US-APWR I&C Design Certification

Technical Report

References Review

Wednesday, February 3, 2010

Table 4.1-3 FMEA for Gr.3 controller, SLS Train A (8/8)

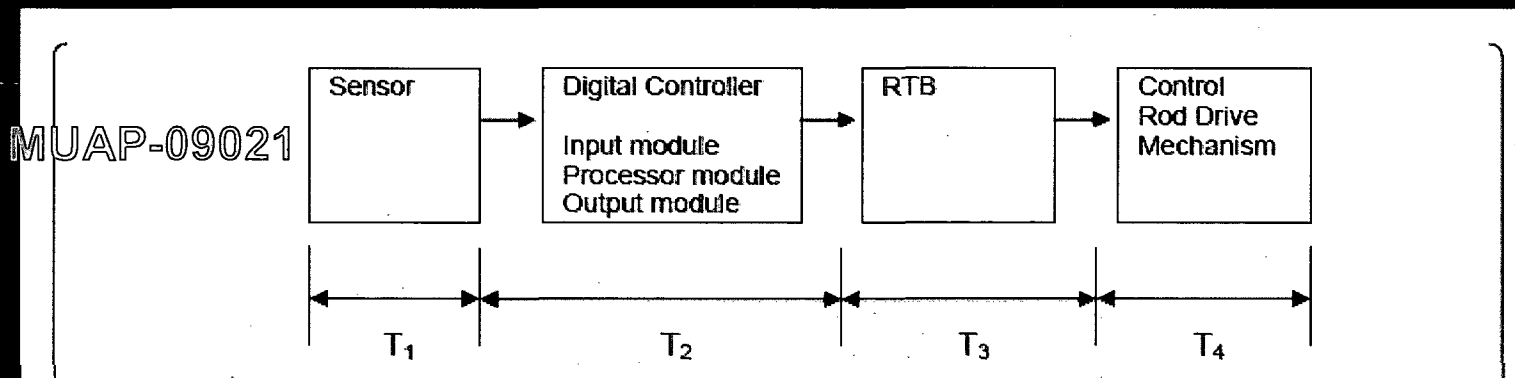
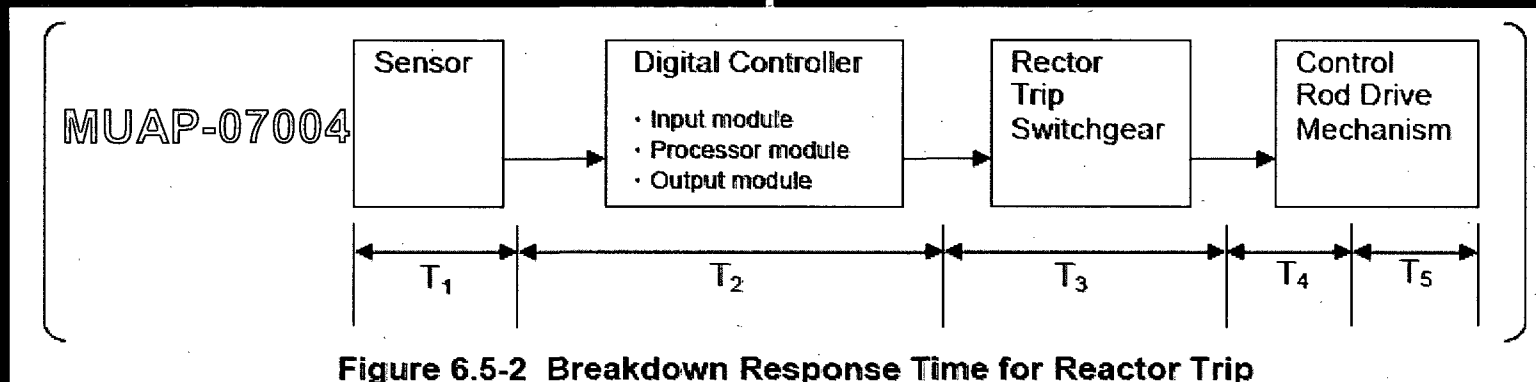
- Does not follow IEEE standards and does not evaluate I&C component failures or identify the modes of these failures, and the effects of these failures
- Suggest revision of this technical report and resubmit for review
